Access Compliance Report

Public Rights-of-Way

(Curb Ramps)

Intersection ID: 29820	Main Street: PROVIDENCE_RD_WEST	Cross Street: WEDGEWOOD_COMMONS_DR	Location: N
ADA ID: 71E9F4B2292C	Ramp Type: PerpDiag	Initial Pass/Fail: Fail	Overall Compliance: No
Severity Score: 22.5			
Codes/Mitigation Info/Possible Solution		Field Measurements/Component Compliance

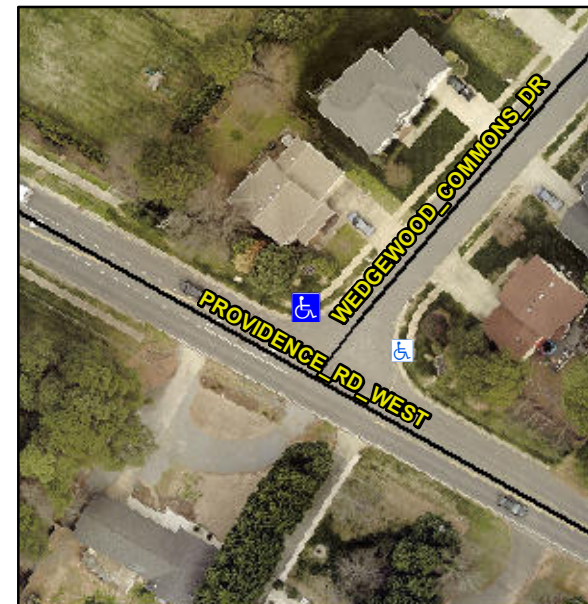
Not Found, R304.5.1, R304.2.2, R304.5.3

Compliance	Description	Data	Compliance	Description	Data
N/A	Ramp Length (in)	42.0	No	Ramp Slope (%)	8.4
No	Ramp Width (in)	46.0	No	Ramp XSlope (%)	3.1
N/A	Flare Type LT	N/A	N/A	Flare Type RT	N/A
N/A	Flare Slope LT (%)	N/A	N/A	Flare Slope RT (%)	N/A
N/A	Flare Traversable LT?	N/A	N/A	Flare Traversable RT?	N/A
N/A	Landing Length (in)	N/A	N/A	DWS Provided?	N/A
N/A	Landing Width (in)	N/A	N/A	DWS Contrast?	N/A
N/A	Landing Slope (%)	N/A	N/A	DWS Length (in)	N/A
N/A	Landing X Slope (%)	N/A	N/A	DWS Full Width?	N/A
N/A	Landing Curb? (Y/N)	N/A	N/A	DWS Offset (in)	N/A
N/A	Shared Landing?	N/A			
N/A	Gutter Ponding?	N/A	N/A	Gutter Slope (%)	N/A
N/A	Gutter Lip Ht (in)	N/A	N/A	Gutter X Slope (%)	N/A
N/A	Painted X Walk1?	No	N/A	Painted X Walk2?	No
	X Walk 1 Direction	To SW		X Walk 2 Direction	To SE
N/A	X Walk 1 Width (in)	N/A	N/A	X Walk 2 Width (in)	N/A
	X Walk 1 Slope (%)	4.1		X Walk 2 Slope (%)	4.2
	X Walk 1 X Slope (%)	6.8		X Walk 2 X Slope (%)	5.0

Remove & Replace Curb Ramp With Two New Directional Ramps or Equivalent.
